San Francisco Bay Conservation and Development Commission

SUBJECT: **Ferry Building Alterations Project in the City and County of San Francisco; Second Pre-Application Review**
(For Design Review Board consideration March 11, 2024)

Figure 4: Proposed Alterations to Entry Portico

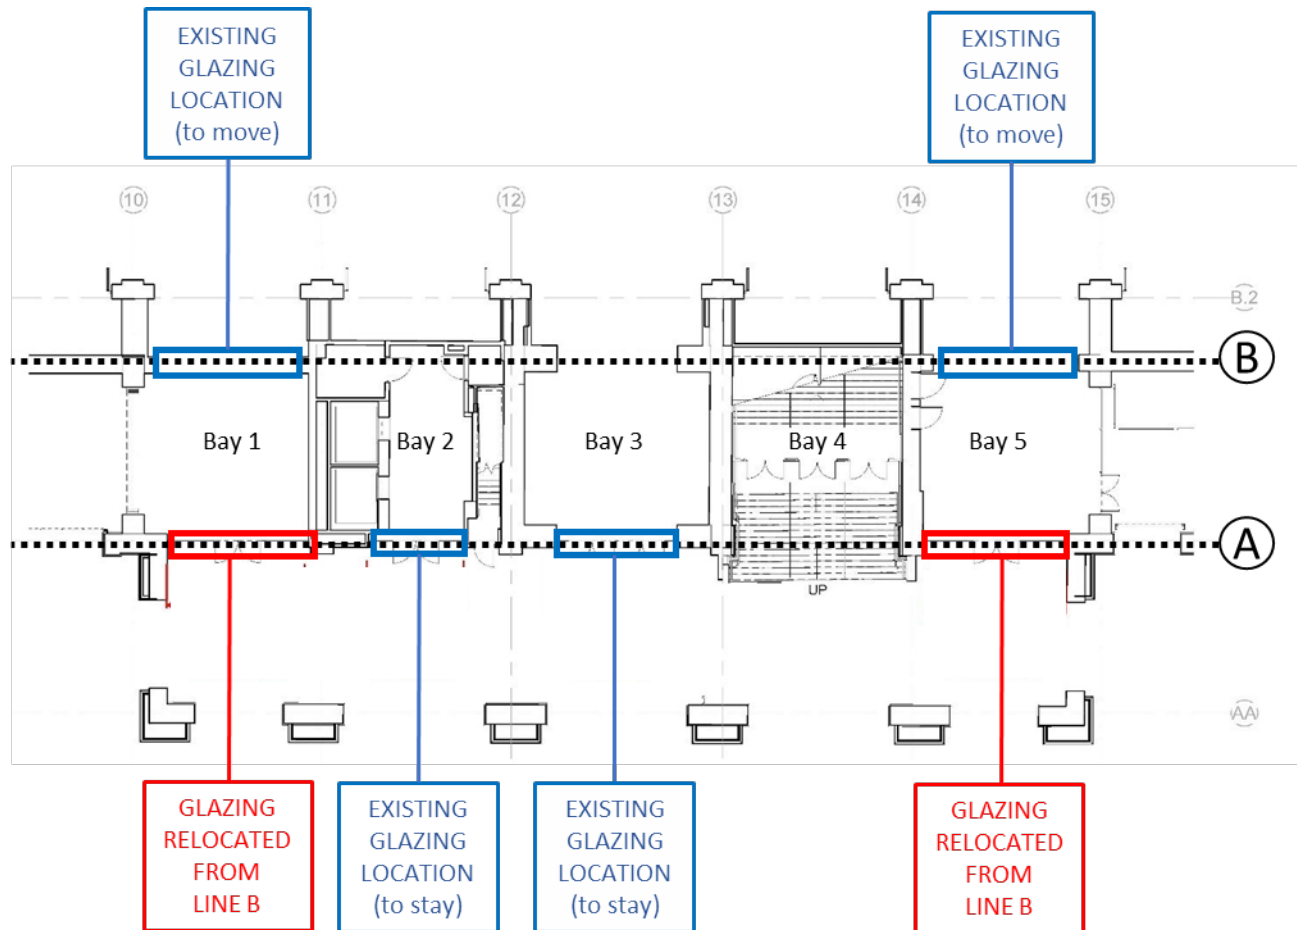
1. Do the proposed alterations reflect the civic nature of the Ferry Building and potential demands for public uses of the site? Is the civic nature of the Ferry Building and surrounding public spaces supported by the materiality and design of the proposed project?

Figure 5: Proposed Alterations to North Arcade

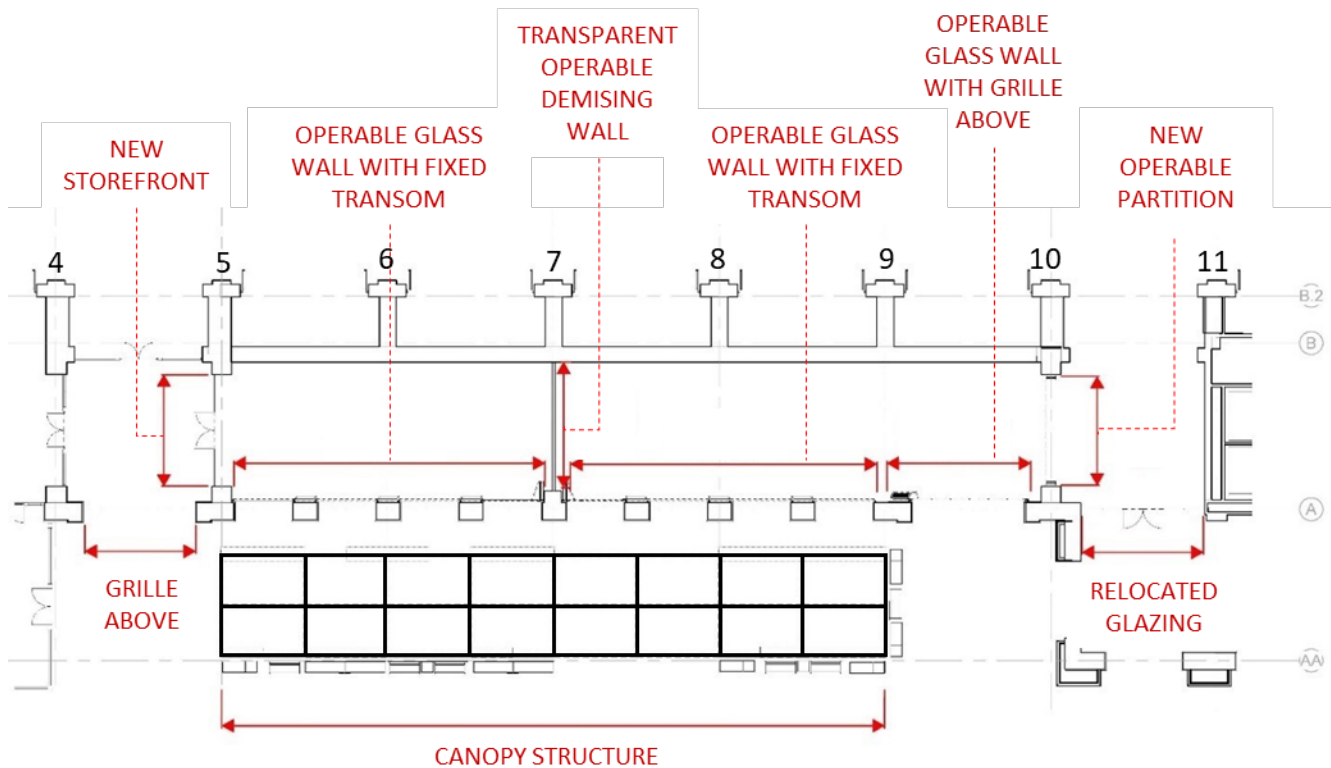
2. Do the proposed alterations sufficiently maintain or enhance circulation and connectivity to and along the shoreline?
3. Do the proposed activation areas along the building frontages collectively and individually promote an inviting and usable public access environment at the Ferry Building and allow for adequate public circulation to site entrances and destinations?
